TABLE OF CHANGES FOR PLANNING AMENDMENTS

Project Title  
UNION, ST. JOHNS

Drawing Title  
WEST ELEVATION

Drawing Number  
6548-P-B500-E-W  
Drawing Status  
PLANNING

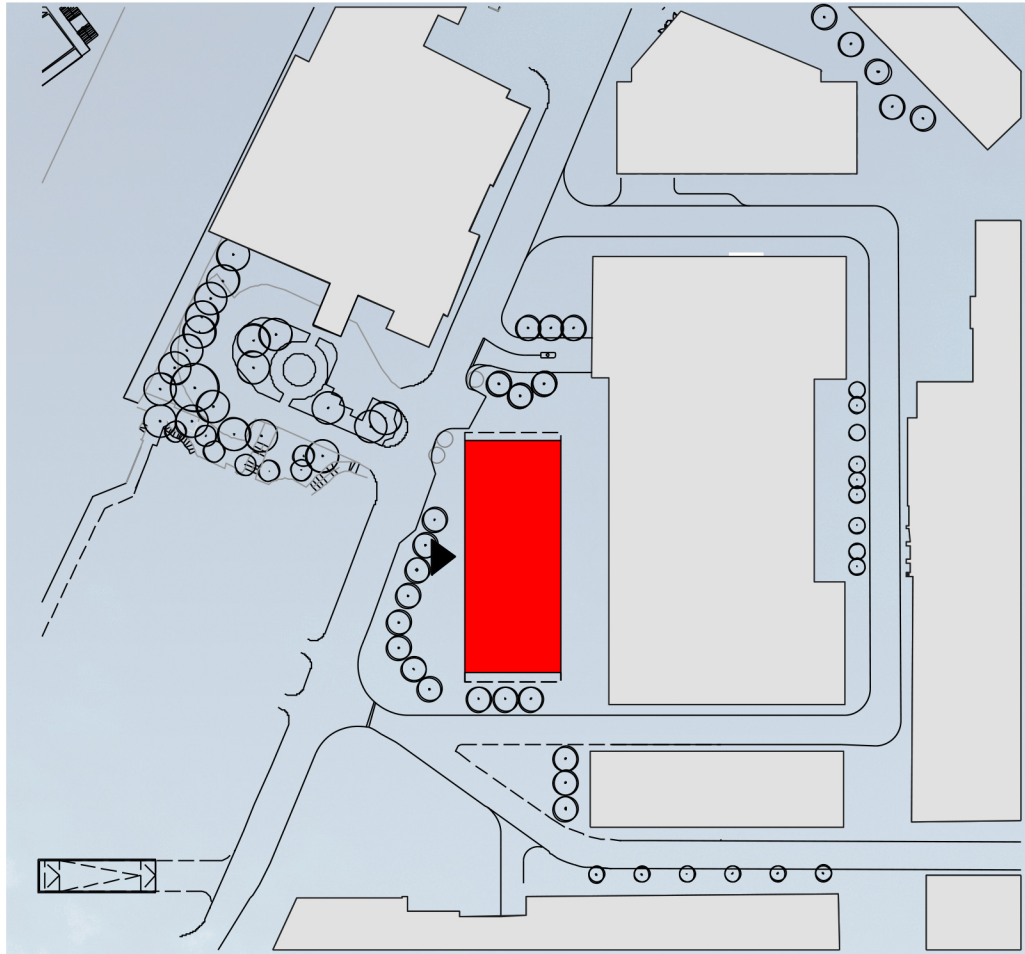
ITEM 3 - LEVEL 01 SPANDREL PANEL MATERIAL AMENDED REFER TO TABLE OF CHANGES

ITEM 2 - MATERIAL REFERENCE AMENDED REFER TO TABLE OF CHANGES

ITEM 6 - NEW FACADE-MOUNTED CLOCK TO WEST ELEVATION REFER TO TABLE OF CHANGES

ITEM 3 - MATERIAL REFERENCE AMENDED REFER TO TABLE OF CHANGES

ITEM 7 - CURTAIN WALLING REFER TO TABLE OF CHANGES

ITEM 1 - EXTERNAL DOORS REFER TO TABLE OF CHANGES

- 1 - EXTERNAL DOORS  
SIZE/ FORMAT OF EXTERNAL DOORS AT GROUND FLOOR AMENDED
- 2 - FLOOR EDGE SPANDREL PANELS AMENDED  
SPANDREL PANELS AT LEVEL 01 FLOOR EDGE CHANGED FROM BLACK BACK-PAINTED GLASS TO BLACK INSULATED OPAQUE ALUMINIUM

- 3 - LEVEL 01 SPANDREL PANEL MATERIAL AMENDED  
SPANDREL PANELS TO WINDOWS AT LEVEL 01 CHANGED FROM BLACK BACK-PAINTED GLASS TO BLACK TINTED GLASS
- 4 - HEIGHT OF EXTERNAL DOORS AMENDED  
HEIGHT OF EXTERNAL DOORS (TO EAST ELEVATION ONLY) REDUCED BY 200mm

- 6 - NEW FACADE-MOUNTED CLOCK  
NEW EXTERNAL CLOCK MOUNTED AT LEVEL 01 TO WEST ELEVATION ONLY
- 7 - CURTAIN WALLING PANELS AMENDED  
CURTAIN WALLING GLAZING PANELS SUBDIVIDED TO SMALLER UNITS
